ADDENDUM NO. 1
TO THE CONTRACT DOCUMENTS
FOR THE CONSTRUCTION OF THE
N. CHICAGO LIFT STATION IMPROVEMENTS
CITY OF SOUTH MILWAUKEE, WISCONSIN

DATE: 15 May 2018

DRAWING 99-E-1 ELECTRICAL DETAILS

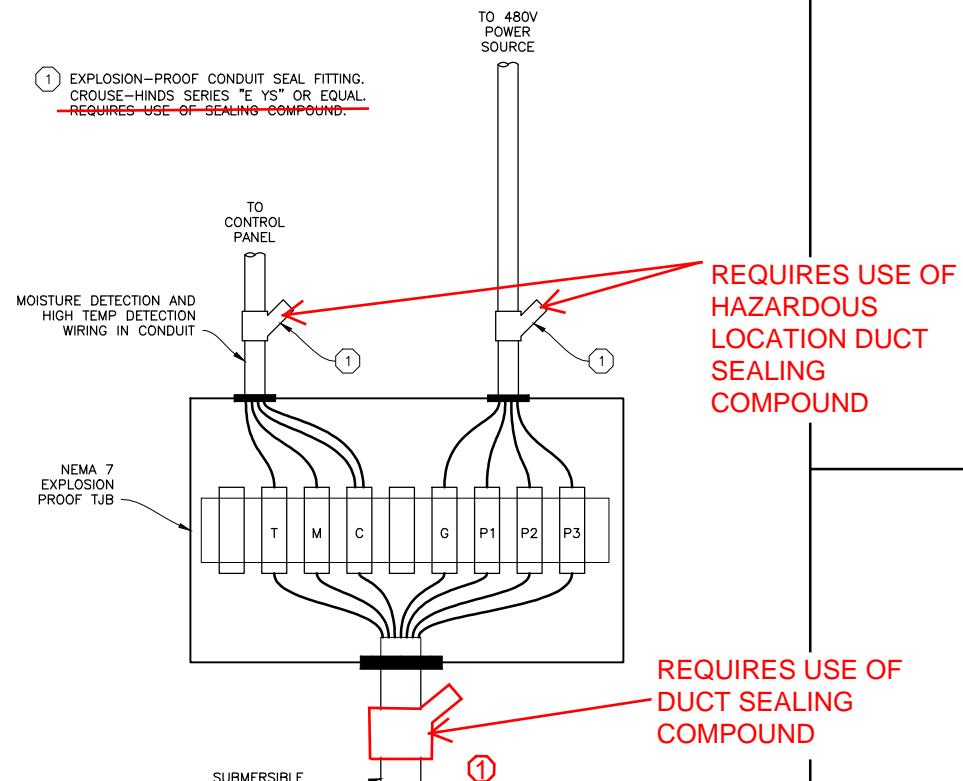
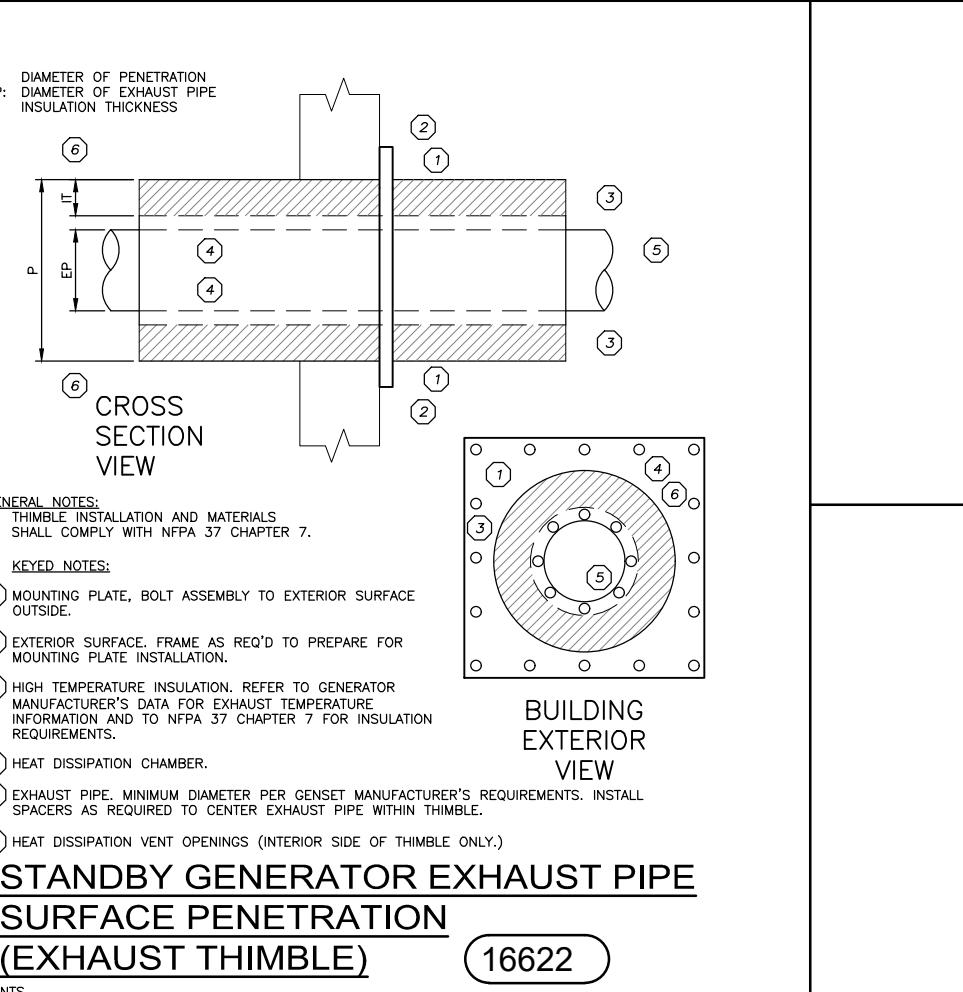
1. Revise the Drawing per the attached Drawing.

<p>SUBMERSIBLE MOTOR CABLE SPLITTING DIAGRAM, HAZARDOUS LOCATION APPLICATION 16261</p> <p>NTS</p> <p>REQUIRES USE OF HAZARDOUS LOCATION DUCT SEALING COMPOUND</p> <p>REQUIRES USE OF DUCT SEALING COMPOUND</p>			 <p>Applied Technologies Engineers-Architects</p> <p>1 5/15/18 ADDENDUM NO. 1</p>
 <p>STANDBY GENERATOR EXHAUST PIPE SURFACE PENETRATION (EXHAUST THIMBLE) 16622</p> <p>NTS</p> <p>P: DIAMETER OF PENETRATION EP: DIAMETER OF EXHAUST PIPE IT: INSULATION THICKNESS</p> <p>CROSS SECTION VIEW</p> <p>GENERAL NOTES:</p> <ol style="list-style-type: none"> 1. THIMBLE INSTALLATION AND MATERIALS SHALL COMPLY WITH NFPA 37 CHAPTER 7. <p>KEYED NOTES:</p> <ol style="list-style-type: none"> 1 MOUNTING PLATE, BOLT ASSEMBLY TO EXTERIOR SURFACE OUTSIDE. 2 EXTERIOR SURFACE, FRAME AS REQ'D TO PREPARE FOR MOUNTING PLATE INSTALLATION. 3 HIGH TEMPERATURE INSULATION. REFER TO GENERATOR MANUFACTURER'S DATA FOR EXHAUST TEMPERATURE INFORMATION AND TO NFPA 37 CHAPTER 7 FOR INSULATION REQUIREMENTS. 4 HEAT DISSIPATION CHAMBER. 5 EXHAUST PIPE. MINIMUM DIAMETER PER GENSET MANUFACTURER'S REQUIREMENTS. INSTALL SPACERS AS REQUIRED TO CENTER EXHAUST PIPE WITHIN THIMBLE. 6 HEAT DISSIPATION VENT OPENINGS (INTERIOR SIDE OF THIMBLE ONLY). <p>BUILDING EXTERIOR VIEW</p> <p>VERIFY SCALES LENGTH OF BAR IS 1" ON ORIGINAL DRAWING 1:2 PLOT SCALE, ADJUST SCALE(S) ACCORDINGLY</p> <p>DESIGNED BY: N.A.O. DRAWN BY: J.T.H. CHECKED BY: F.X.T. APPROVED BY: W.A.E. PROJECT NO. 5795 DATE APRIL 2018 DRAWING NO. 99-E-1</p>			 <p>city of South Milwaukee Proud Past... Promising Future</p>
